Title		
Size	Number	Revision
A4		
Date:	1/11/2023	Sheet of
File:	PowerSupply.SchDoc	Drawn By:

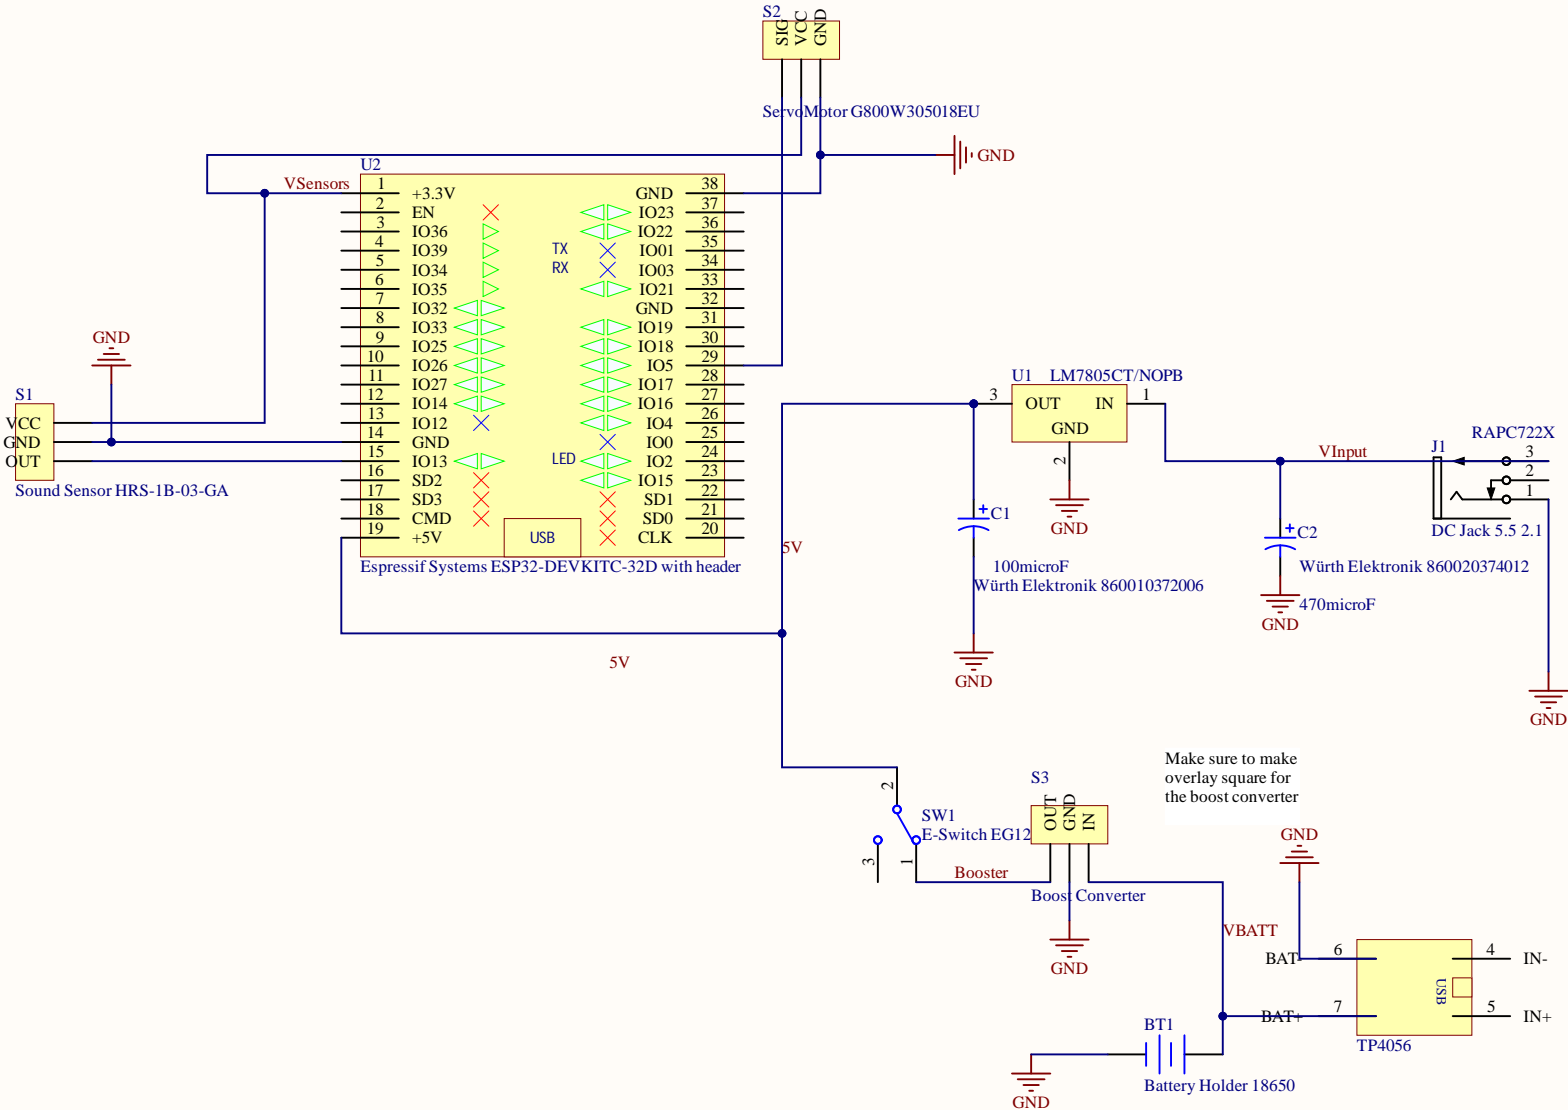
Verify pinouts and ordering for sound sensor and servo motor

IDK which is ground and which isn't try switching it around before pcb and seeing if warning comes

Make sure to make overlay square for the boost converter
